**RE: Response Letter
Notice of Intent – Parallel Products (SE49-0771)
100 Duchaine Blvd. – New Bedford, Massachusetts**

We have enclosed a response letter, revised HydroCAD calculations, revised Site Plan sheets and accompanying documentation in response to the comment letter prepared by Nitsch Engineering dated October 17, 2017 in regards to their review of the Site Plans and attached documents.

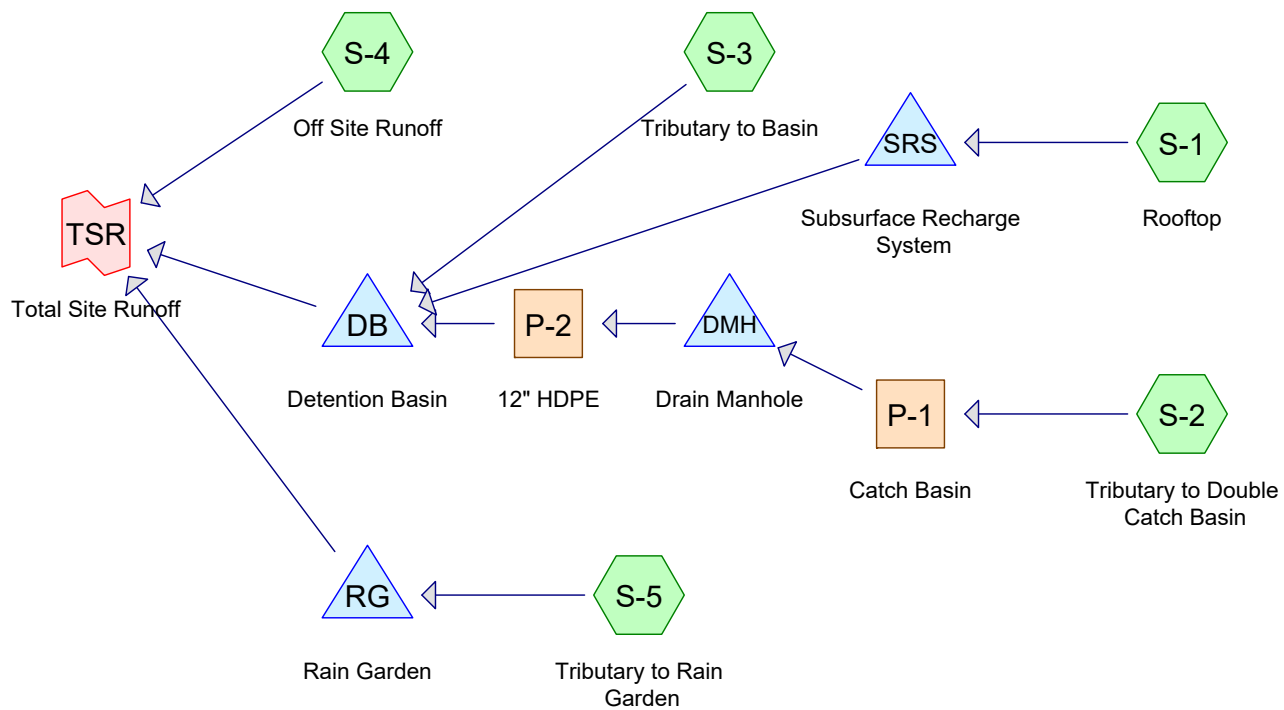
We recommend the underground piping be labelled for size and pipe material.

Pipe sizes and material have been added to the plan.

TYPICAL CONNECTION OF OVERFLOW DISCHARGE MANIFOLD

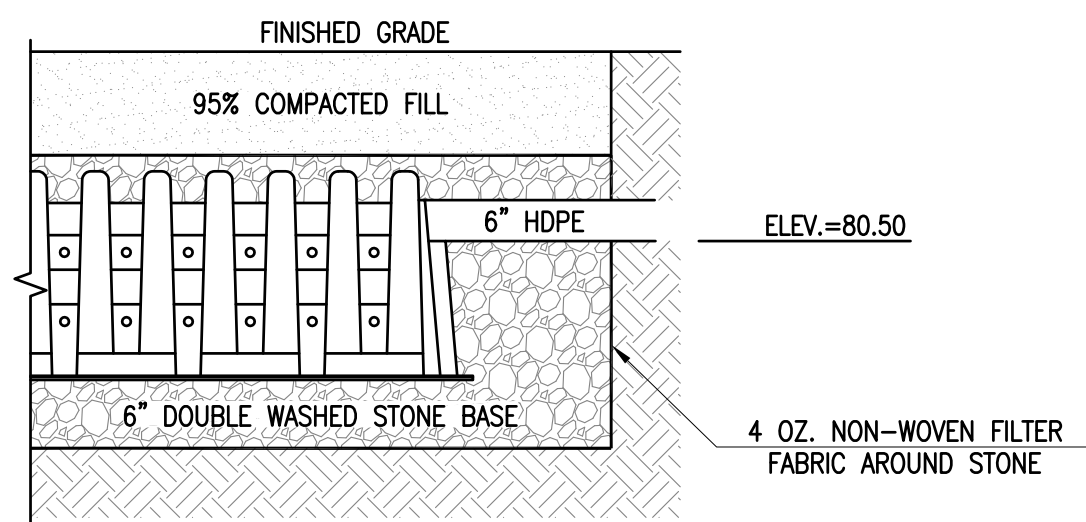
We recommend that additional information be provided describing the outlet control structure from the underground infiltration system. The calculations show one six-inch reinforced concrete pipe controlling the flow from the leaching system. Six-inch reinforced pipes are not manufactured. The detail shows the invert at the bottom of the chambers. The plans show four outlet pipes, one from each row of recharge units. Details need to be provided that are consistent among the calculations, plans and details, and are clear for the contractor to build.

Discrepancies within the plans and calculations have been revised to be consistent with one another. Additional descriptions have been added to the plans and details to show the proposed construction of the outlet manifold structure.

WATER QUALITY INLET STRUCTURE – STORMCEPTOR STC 450i

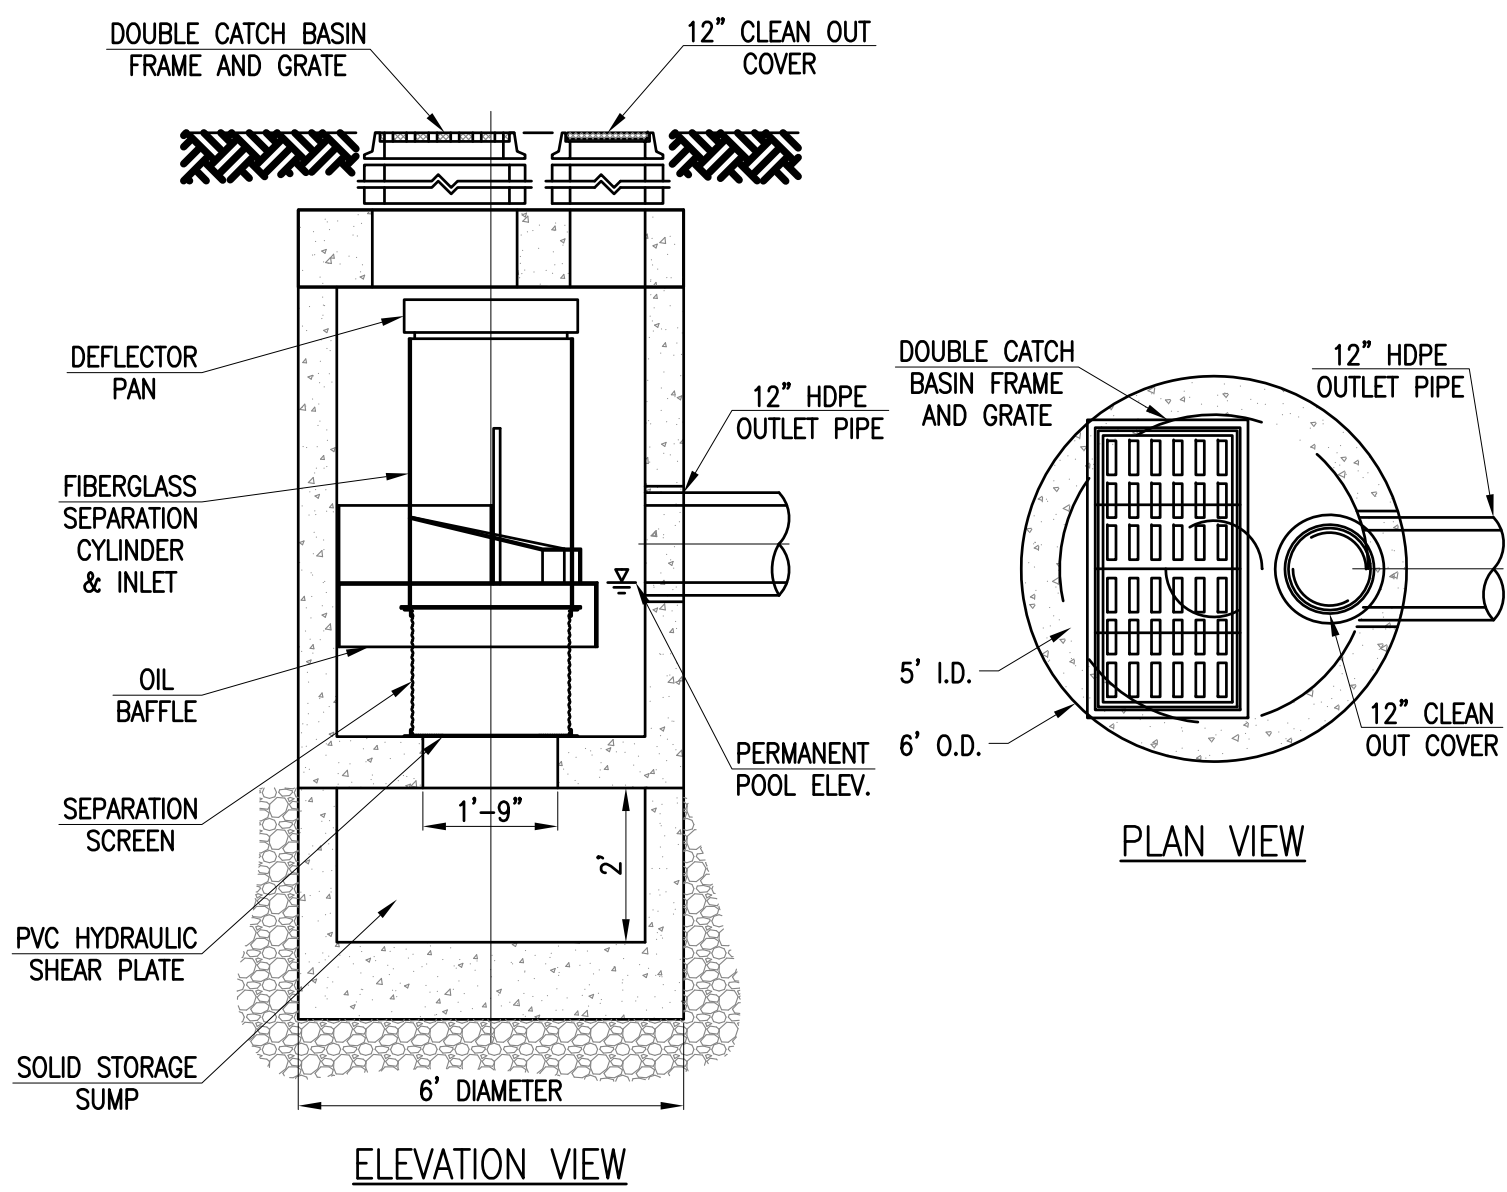
A water quality unit detail was added to the plans. The detail is generic and does not specify the manufacturer. The detail should show the manufacturer or type of unit proposed by the applicant.

The water quality unit detail has been updated to show model and type of the proposed unit.
